BEL AIR EXECUTIVE PARK SUBDIVISION, SECOND UNIT, RESUBDIVISION OF LOTS 27, 28, AND 29

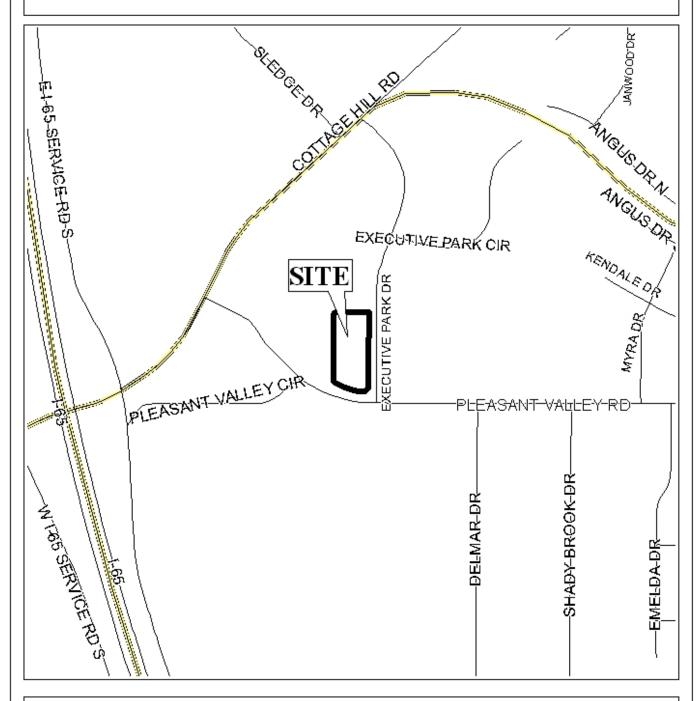
Since the creation of the lots, the right-of-way of Pleasant Valley Road was widened in order to change the route of the street to accommodate a new intersection with Cottage Hill Road. The plat provided with this application reflects the original 1978 layout, not the more current layout resulting from the acquisition of additional right-of-way for Pleasant Valley Road. The plat should be revised to reflect the changes.

Based on the preceding, the plat is recommended for Holdover until the May 3rd meeting to allow the applicant's representative to revise the plat to reflect the current right-of-way for Pleasant Valley Road, and thus the boundaries of the lots. Revisions should be submitted to the Planning Section of Urban Development by April 10, 2007.
